**CANAL 111 (C-111) BASIN
SOUTH DADE COUNTY, FLORIDA**

**ENVIRONMENTAL ASSESSMENT AND
FINDING OF NO SIGNIFICANT IMPACT**

**EXPANSION OF THE C-111 DETENTION AREA AND
ASSOCIATED FEATURES**

**Expansion of the C-111 Detention Area and Associated Features
Environmental Assessment**

Figure 4: Expanded S-332B NDA and Associated Features

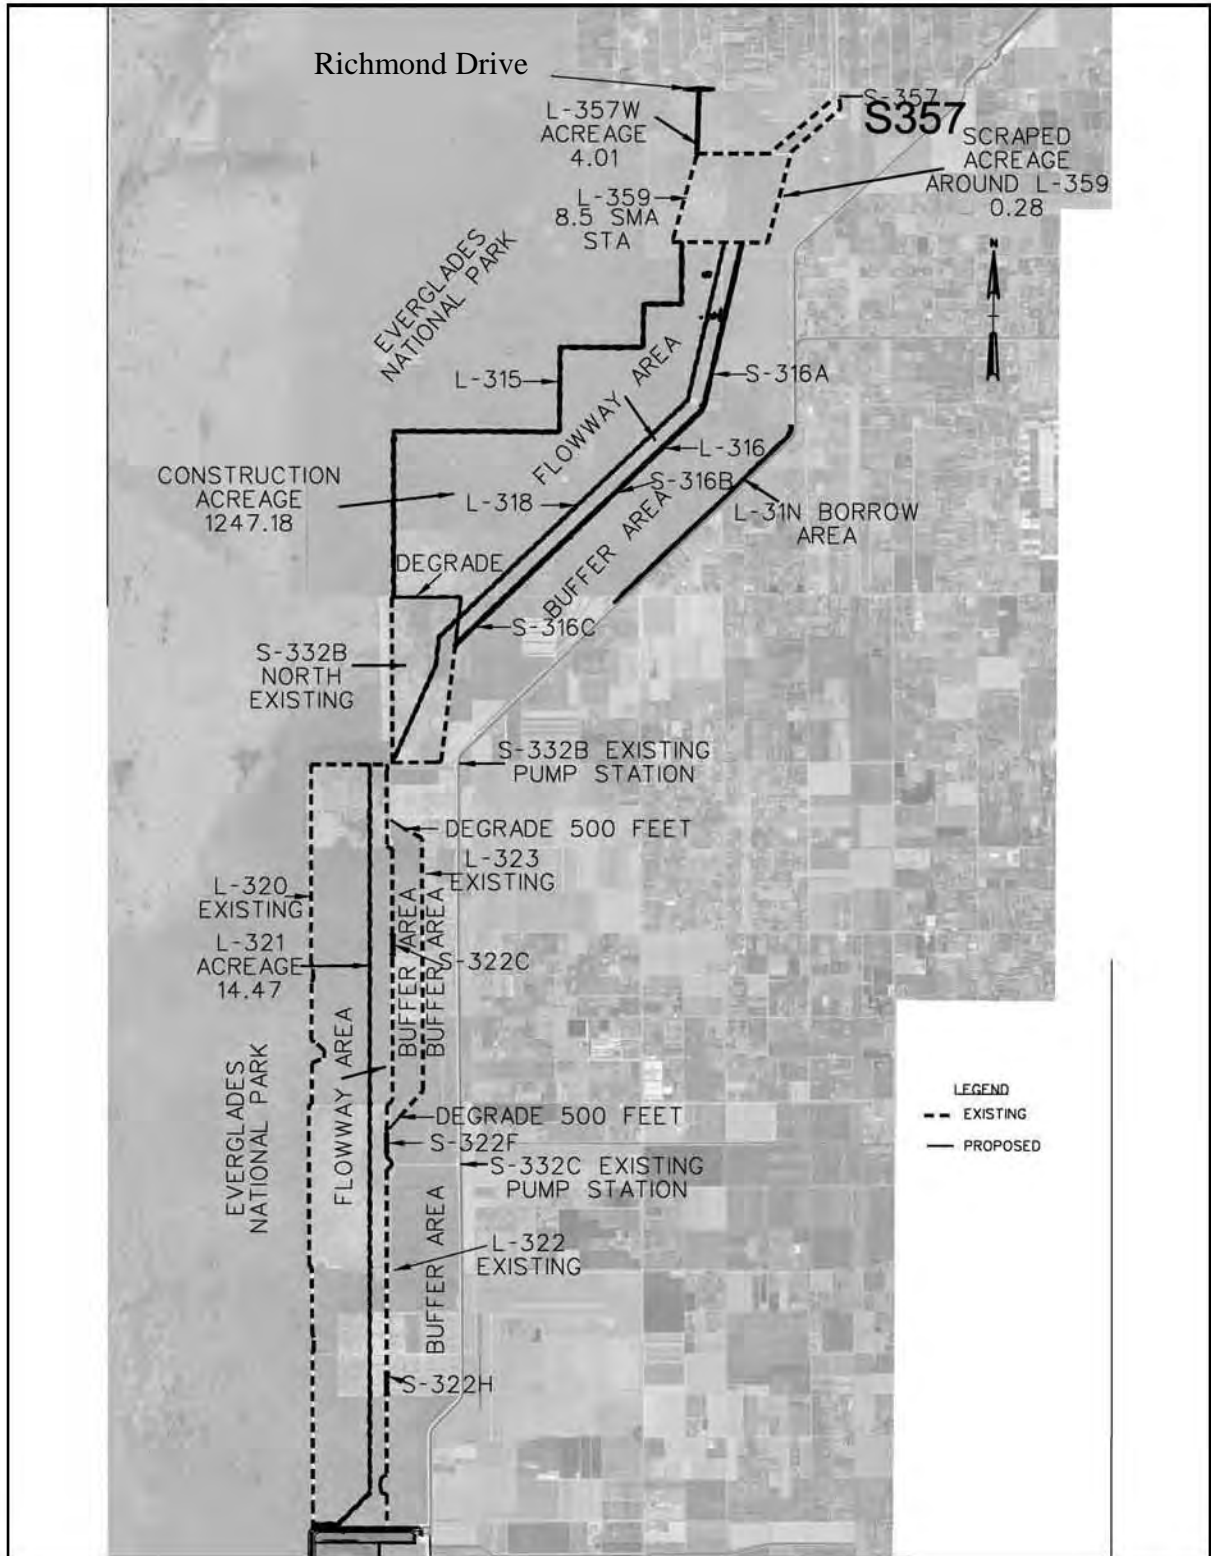
FDEP – 11	Section 2.1.3. The Alternative 3 paragraph makes reference to the North Detention Area (NDA) being divided into two areas: the flow way and the main detention area. Figure 4 does not show these areas and should be updated to clearly depict their location.	Figure 4 has been updated to reflect this change.

SFWMD – 2	Describe the solid line along the L-31 Canal located near the same latitude as the Northern Detention Area (NDA) in Figure 4.	The solid line is the location of the disposal material that will come from the NDA. The line is now labeled on Figure 4.
SFWMD – 3	Indicate where and/or how the 8.5 Square Mile Area (SMA) will be modified in order	The 8.5 SMA detention area is not being modified as part of this contract; changes to the 8.5 SMA detention area to allow discharge to
